<i>NCSX RFD</i> <i>Part I</i>	Number: 14-018R1	RFD Description: Type A2-A6 MCWFs Flange Hole Modifications
Initiator: Mike Griffith		Organization: Major Tool
List of Impacted Documents: (<i>Specification, MIT/QA Plan, SOW, drawing, etc.</i>): SE141-114		
Cost Impact: (<i>If none, so state</i>): NONE		
Schedule Impact: (<i>If none, so state</i>): NONE		
Quality Impact: (<i>If none, so state</i>): NONE		
State Requirement Deviation is Requested For: (<i>Specification, MIT/QA Plan, SOW, drawing, etc.</i>): SE141-114		
<p>Full Description of the Deviation Requested: (<i>Use continuation pages, e-mails, letter, sketches, etc. as needed and include amplifying information as appropriate to support deviation request.</i>):</p> <p><i>Revision 1 to this RFD removed the Type A1 MCWF– it will be the subject of RFD-14-020. This RFD now only addresses Type A2 through A6 MCWFs.</i></p> <p>Major Tool noted casting interference at the bolt locations as shown in the attached figures for the Type A castings – see Attachment (1). This casting interference is similar to what was noted on the Type C winding forms, but more are severe in these areas for the Type A MCWFs. NCSX reviewed the remaining flang

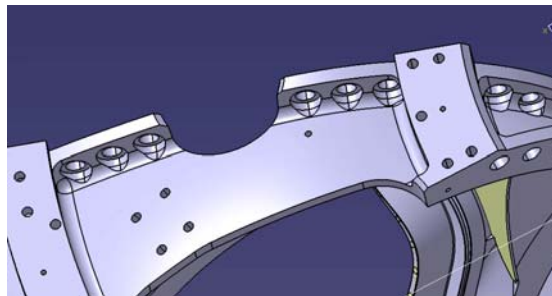
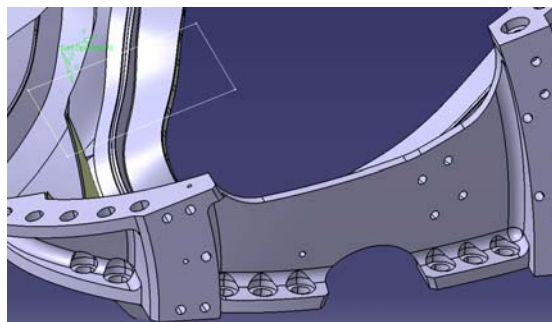
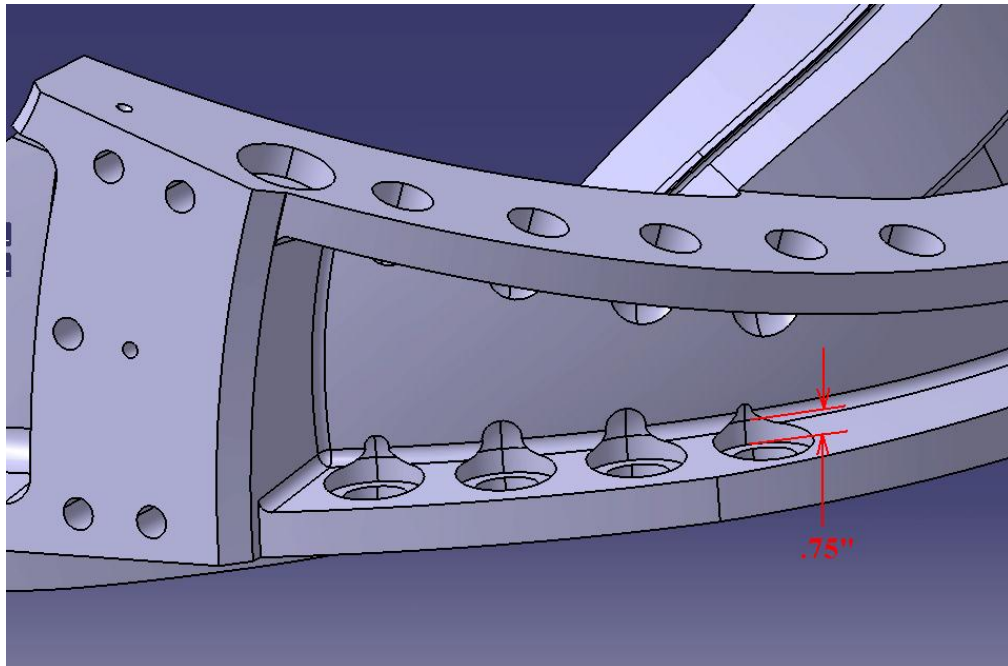
Relief area cut into cast wall

The pictures below illustrate how much casting wall interference there will be on the type A casting. The current machining models for all three winding forms have this interference problem to some degree. The models have a 3" counterbore that extends .75" from the face and the remainder of the feature is a 1.5" radius (see below). This is why Major Tool had to perform the grinding around the counterbores on C4 in order to get the 3" diameter gage to fit.

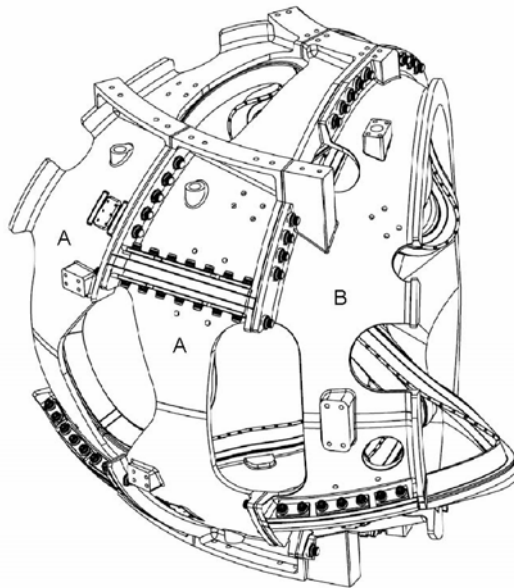
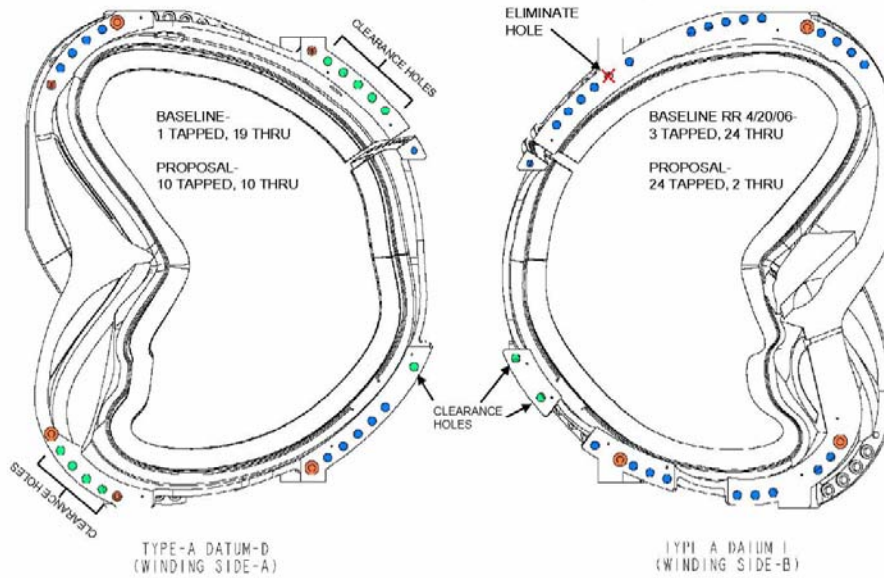
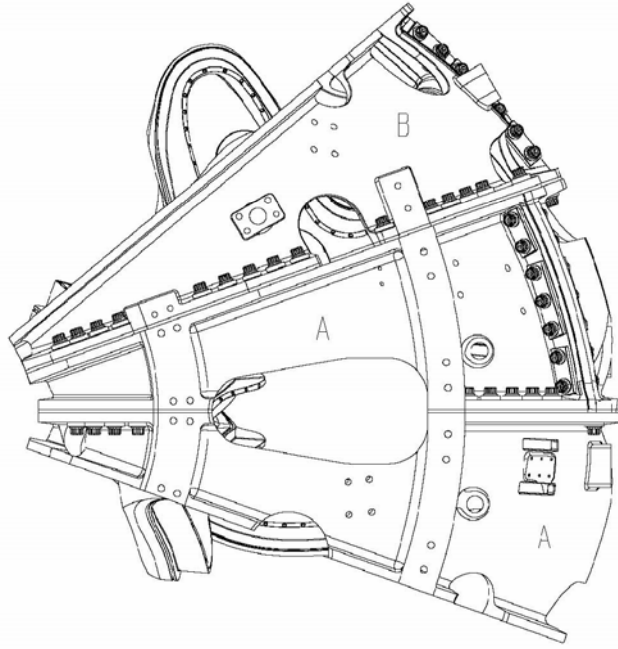
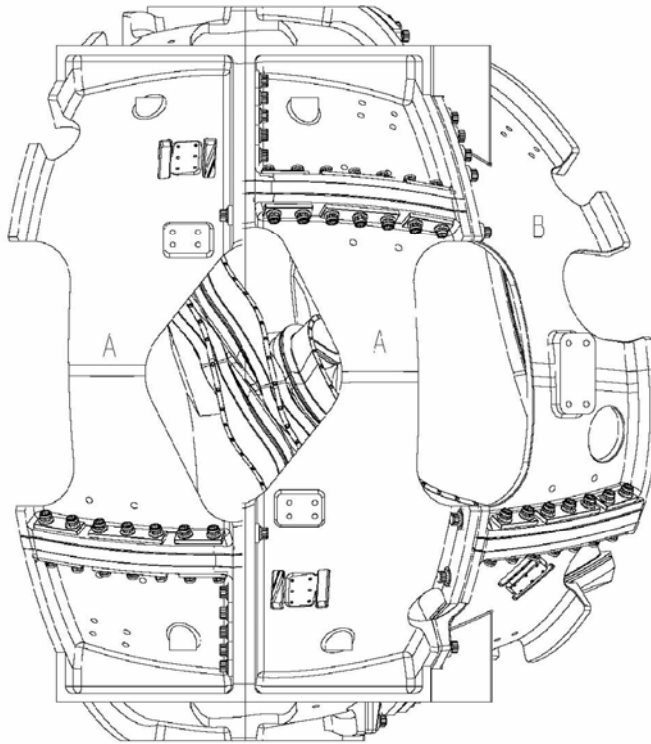
RESPONSE TO M. GRIFFITH / MTM PROPOSAL TO
CONVERT THRU HOLES TO TAPPED TO MINIMIZE
CUTTER INTERFERENCE WITH HEAVY STOCKED
CASTING WALL

- ALIGNMENT FEATURE
- $\varnothing 1.375-6$ UNC-2B THRU
- $\varnothing 1.885-1.003$ THRU
□ $\varnothing 3.0$ BACKSIDE X MIN DEPTH

<i>NCSX RFD</i> <i>Part III</i>	Number: 14-018R1	RFD Description: Type A2-A6 MCWFs Flange Hole Modifications
RLM: Brad Nelson		Organization: ORNL
Impact on Interfaces with Other WBS Elements/Items: (If none, so state): NONE		
<p>RLM Recommendation:</p> <p><input checked="" type="checkbox"/> Approve <input type="checkbox"/> Do Not Approve</p> <p>Additional remarks:</p> <p>This RFD also includes a modification by the NCSX Project for the identified Type A2 through A6 MCWF flange holes - See Attachment (2). <i>The milling machine should be programmed to tap to a depth of 1.5" from the front flange face (recognizing that some flange areas may be less than 1.5" thick and therefore the thread length may be less than 1.5" for some holes).</i></p> <p>These modifications will be incorporated in a future revision to this drawing. In the interim that "stamp" process will be used to annotate SE141-114.</p> <p>Does this Change Impact Material Already Procured or Parts/Assemblies Already Assembled/Manufactured using this Material: <input checked="" type="checkbox"/> Yes <input type="checkbox"/> No</p> <p>If "Yes", what is the recommended disposition of this material/part/assembly? A1 Casting will be accepted "as is" with the exception of the two holes shown.</p>
